**NARRAGANSETT BAY COMMISSION
ONE SERVICE ROAD PROVIDENCE, RI 02905**

**CSO PHASE IIIA
OF-217 Consolidation Conduit
CONTRACT 308.05C**

**ADDENDUM NO. 1
August 19, 2021**

PROFILE
SCALE: 1" = 20' (H)
1" = 5' (V)

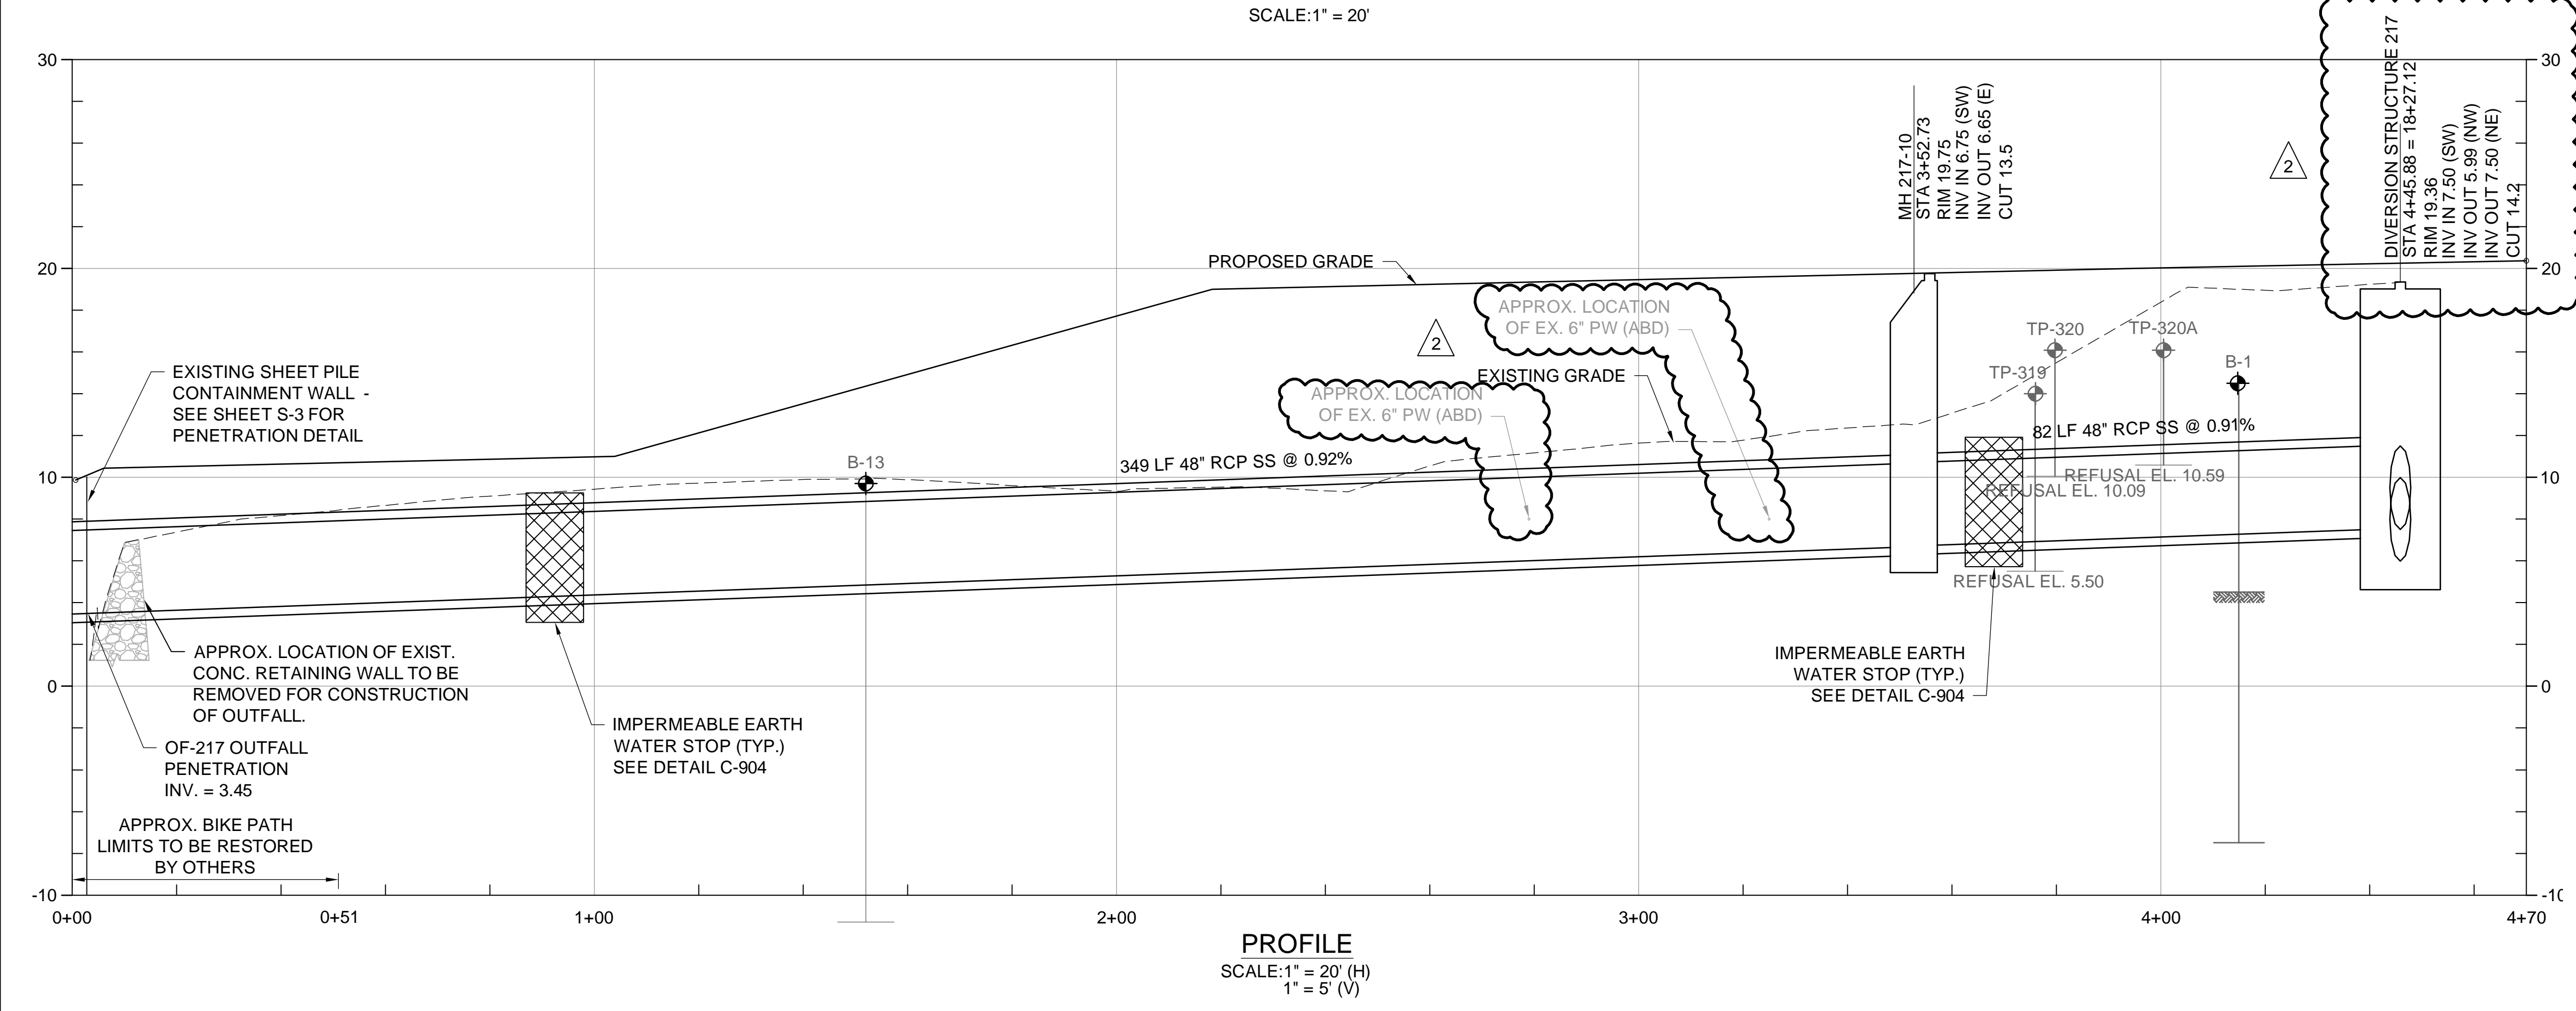
Item 1-8: Drawing C-3 shall be **DELETED** and **REPLACED** with Drawing C-3 attached hereto (see Addendum No. 1, Attachment 6).

1. Sheet C-3 indicates the limit of sidewalk restoration but does not indicate any pavement restoration for any open cut pipe installation in the roadway. Is the intent to only patch the trench in accordance with details C-911 and C-912?

Response: Correct. Temporary and permanent trench paving is required in accordance with C-911 and C-912 for sections of pipe within paved surfaces that are installed utilizing open cut construction techniques.

SHEET
C-8
195130227

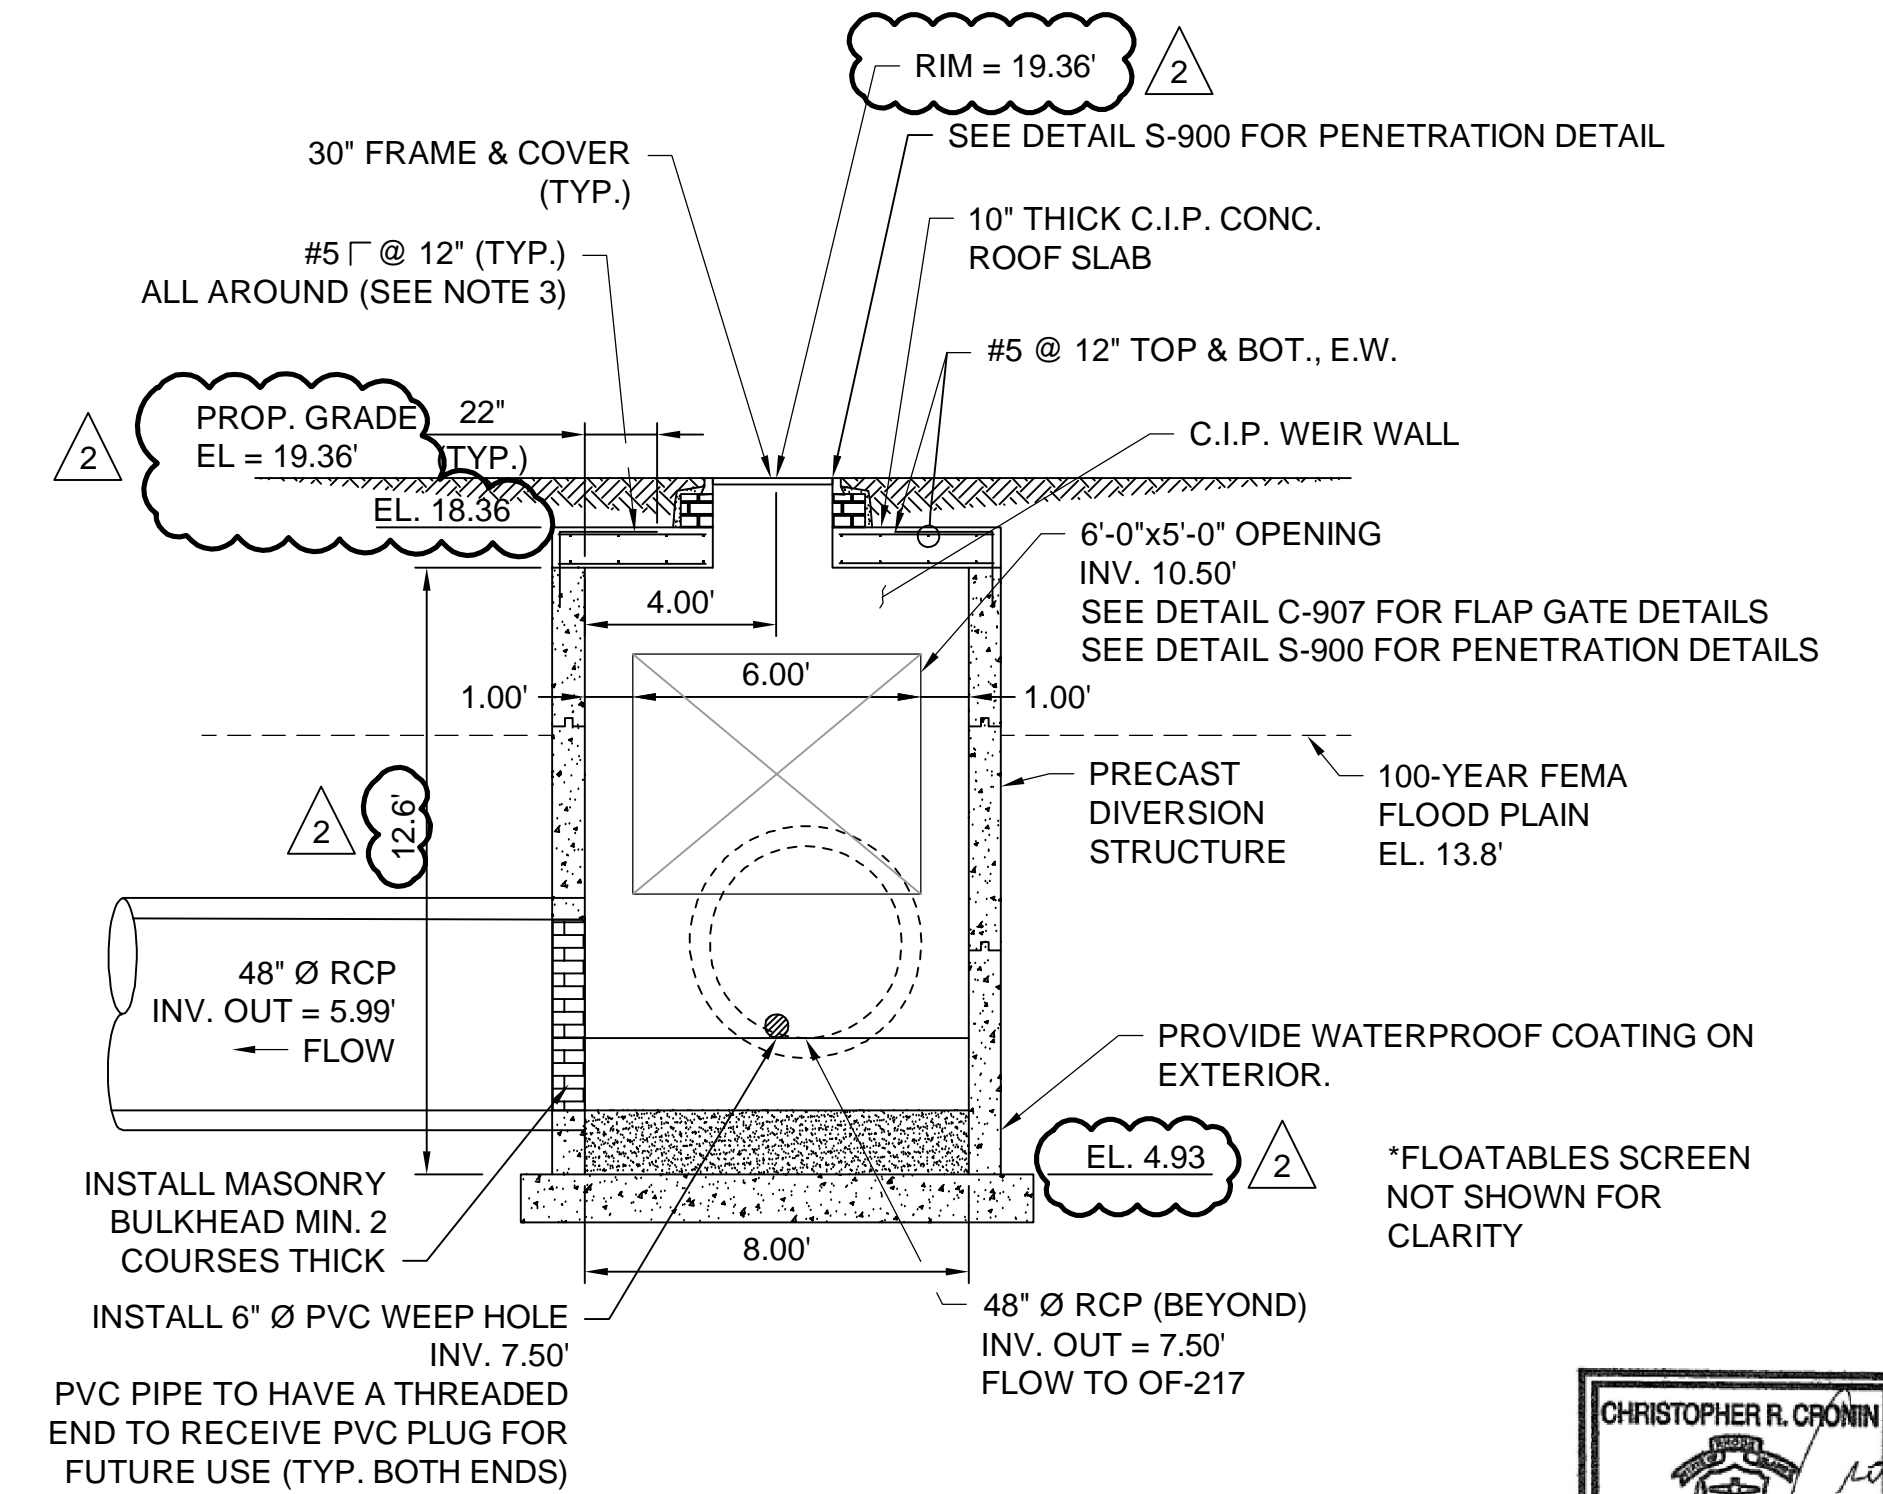
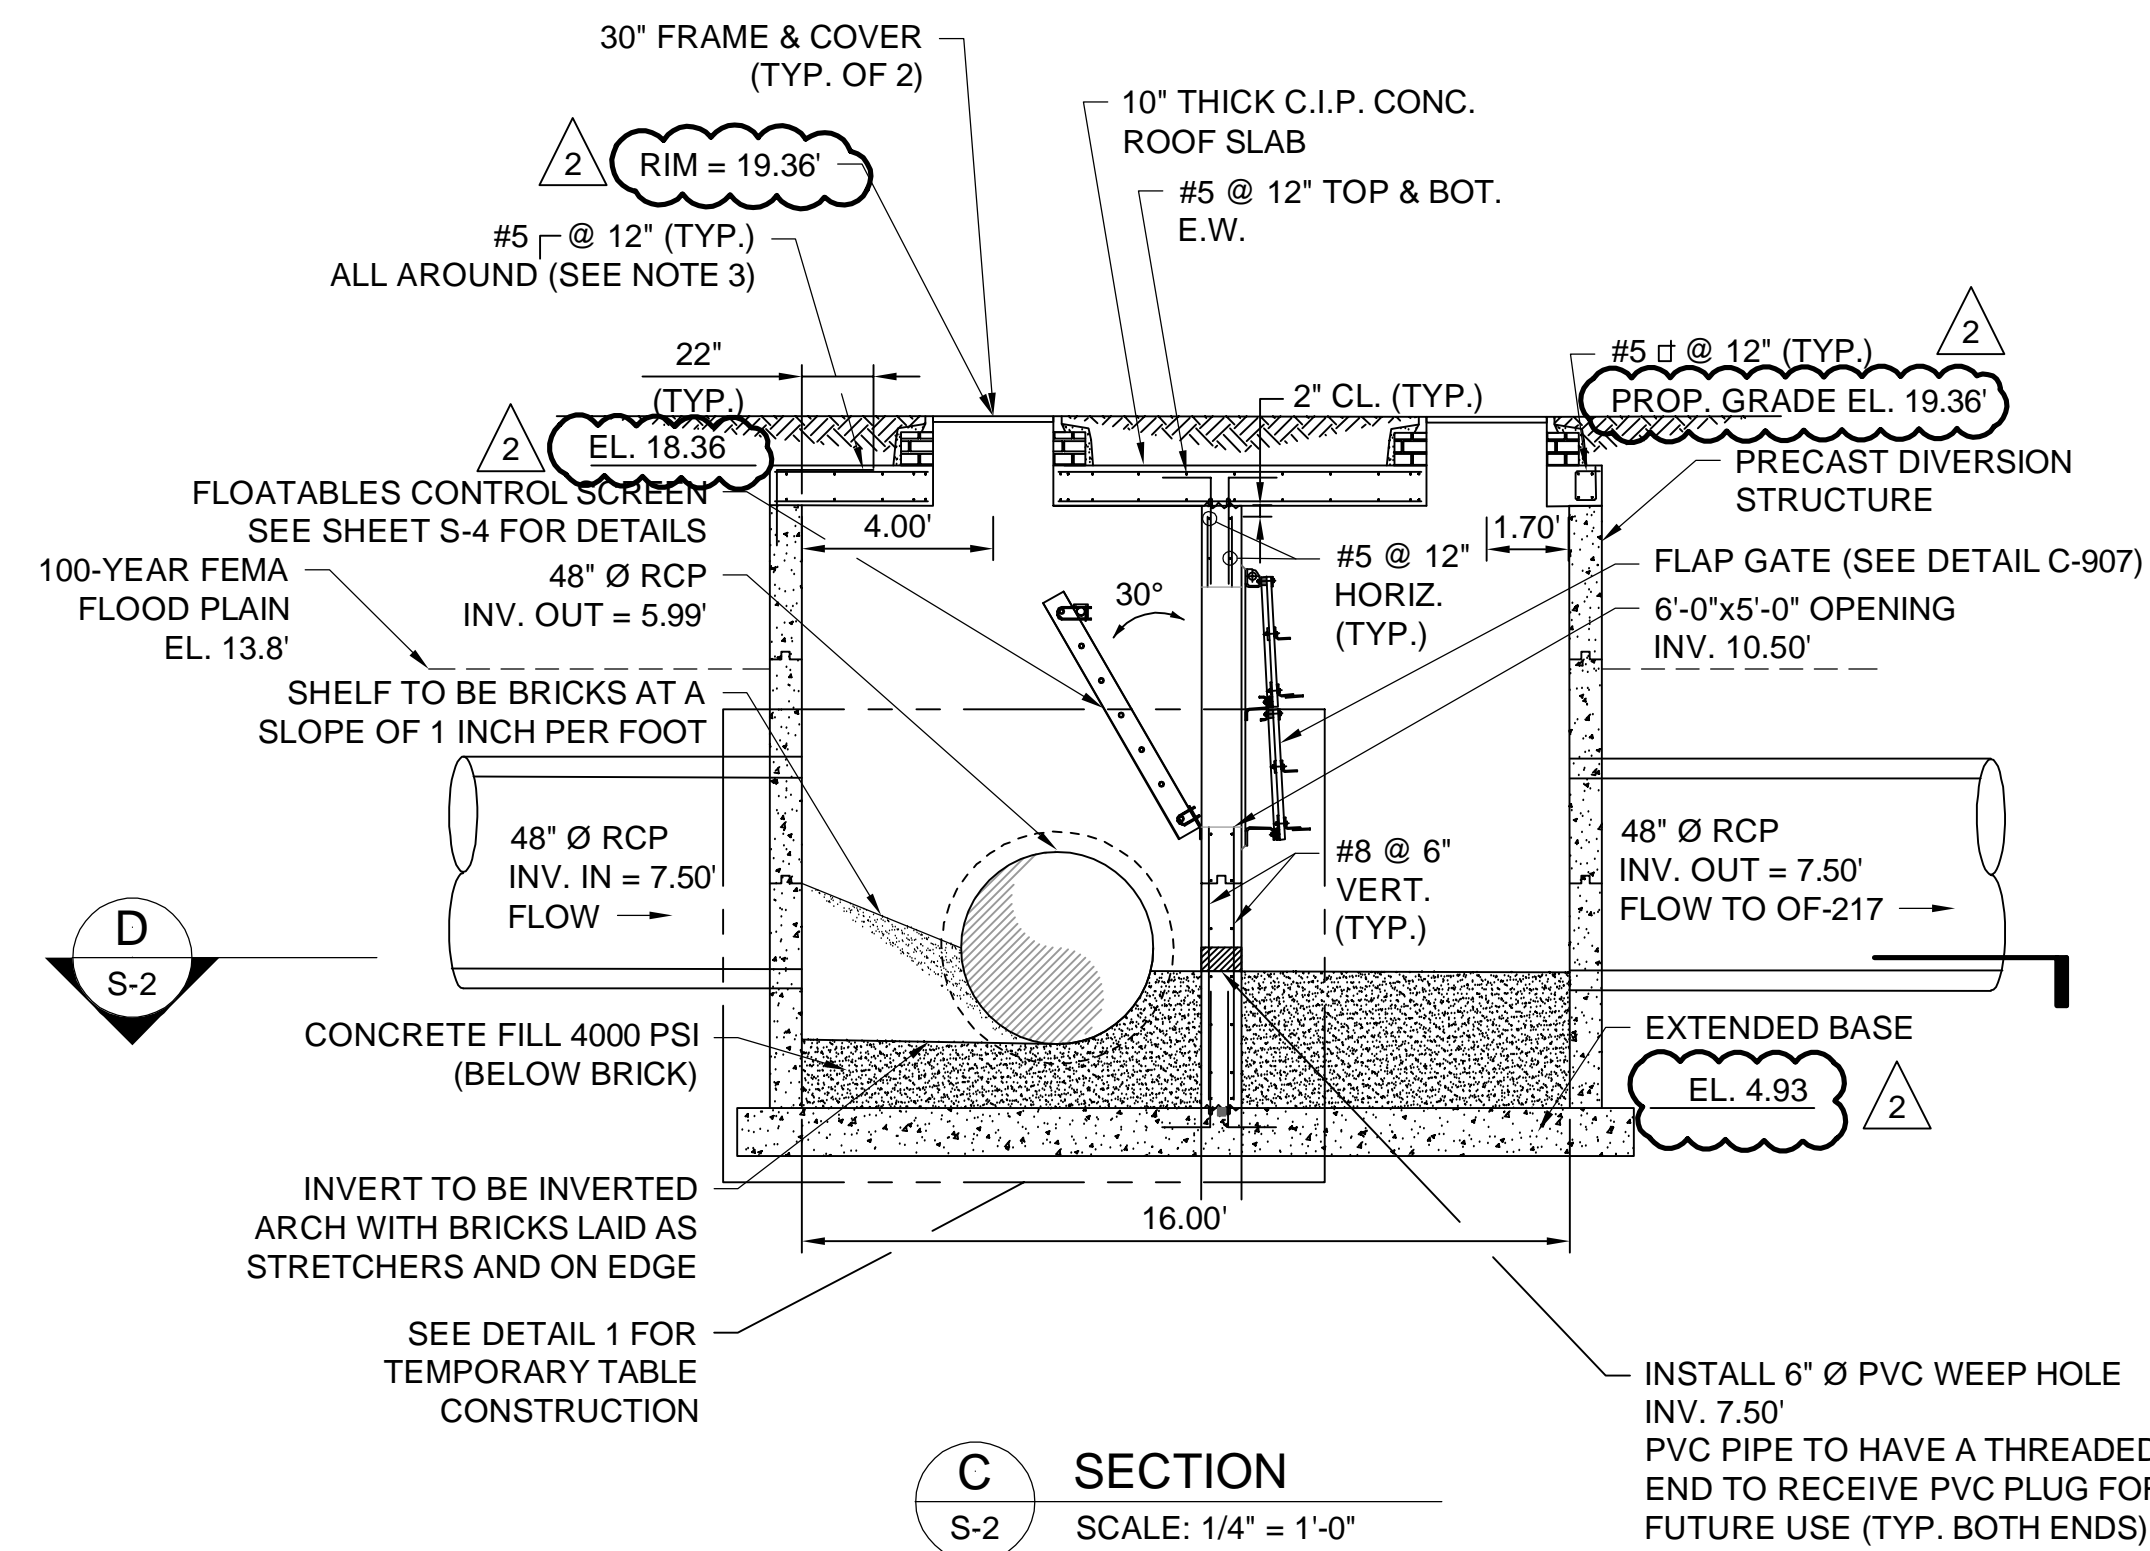
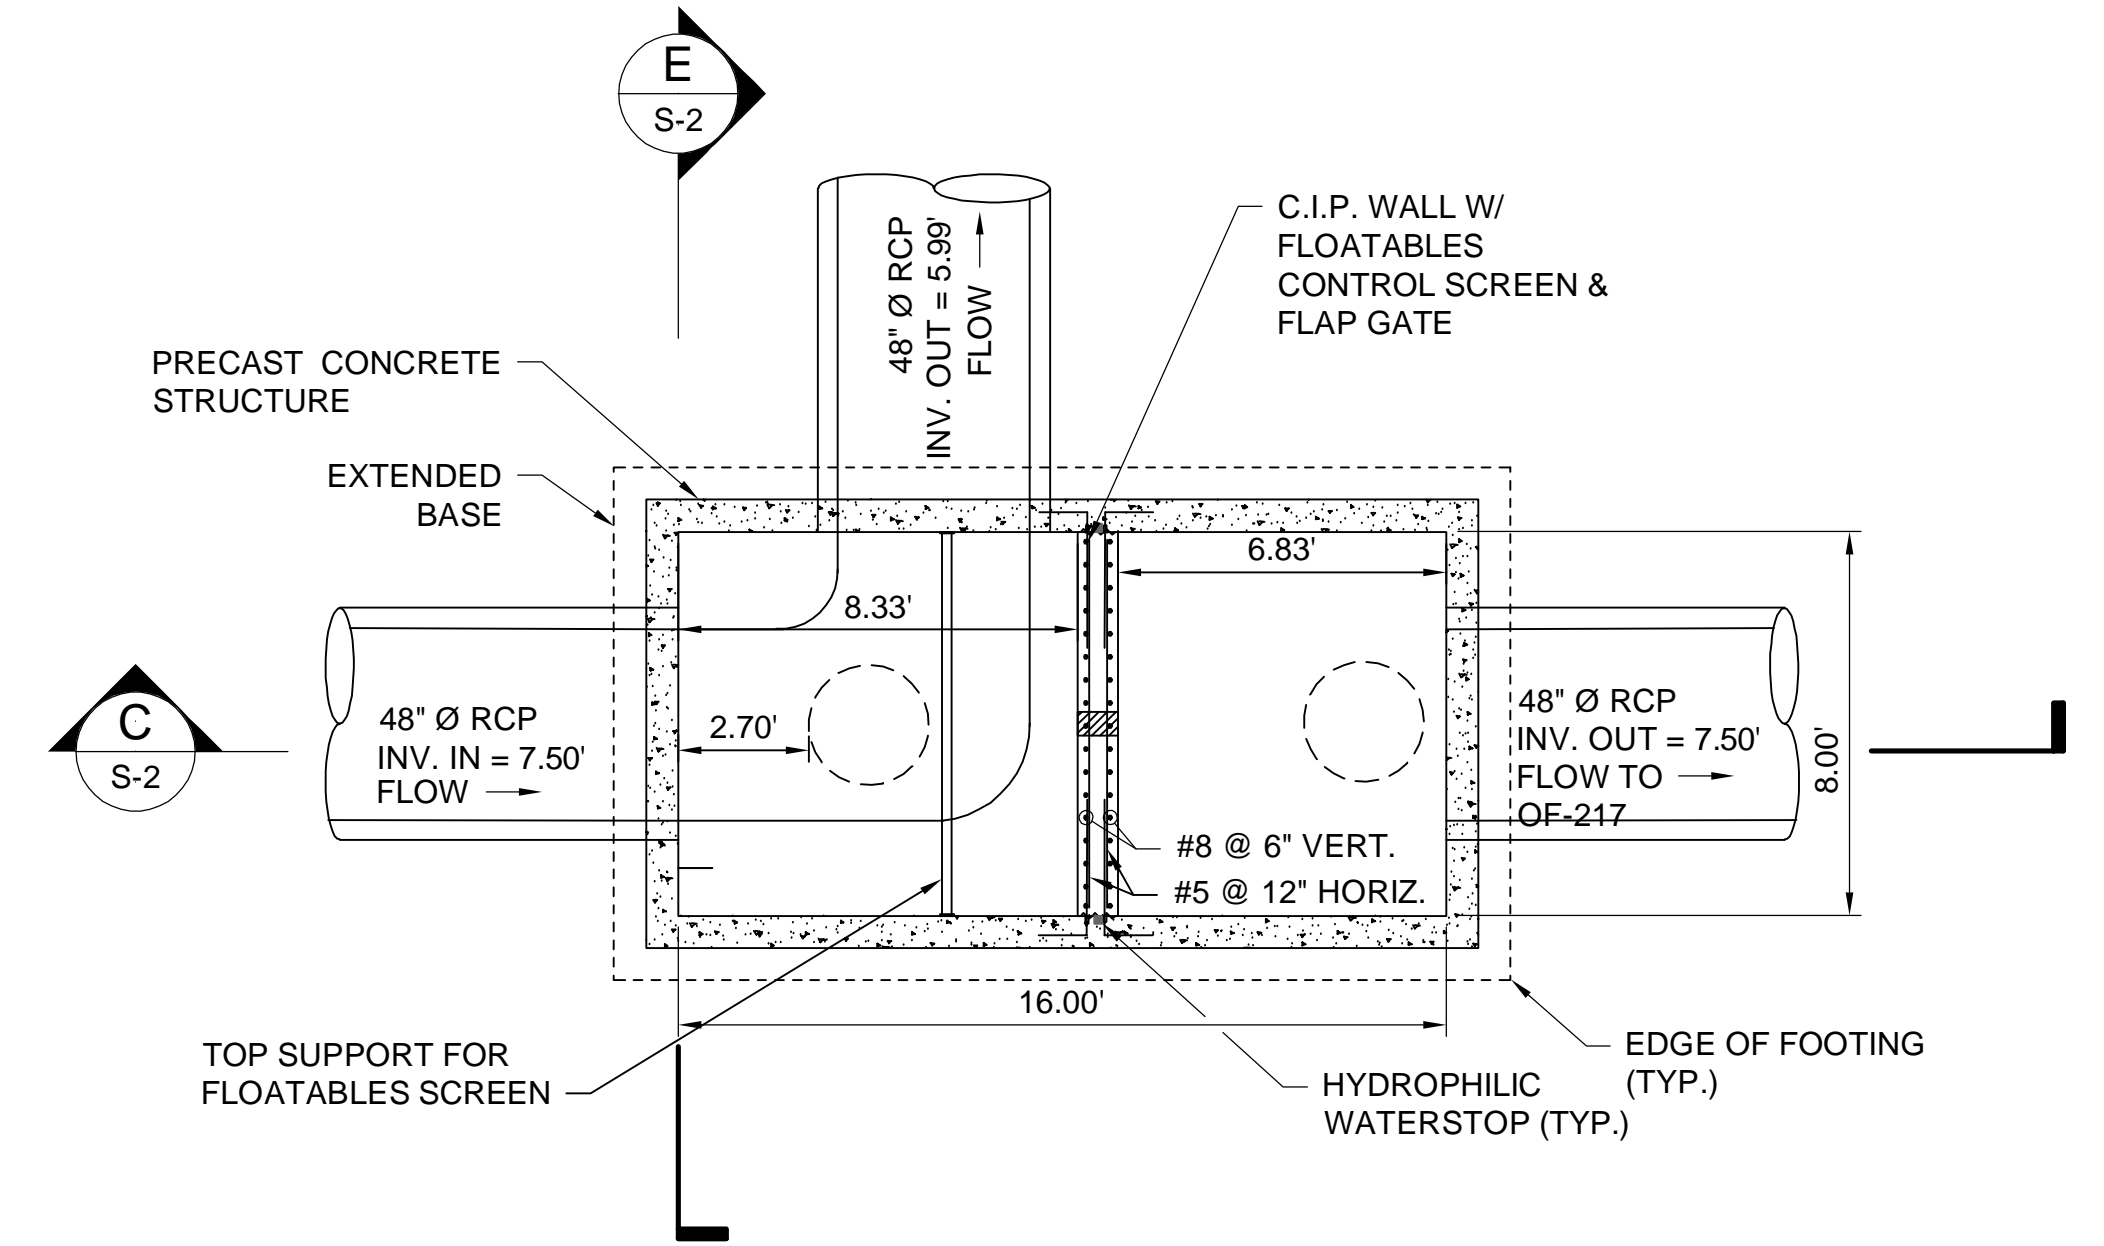
Item 1-9: Drawing C-8 shall be **DELETED** and **REPLACED** with Drawing C-8 attached hereto (see Addendum No. 1, Attachment 6).

4. Sheet c-8 profile shows two 6" water lines at stations 2+80 and 3.12 but they are not shown on the plan. Are they in fact there and if so, do will they require cutting and capping?

Response: Water mains are known to be abandoned. Please see Addendum 1, Item 1-9.
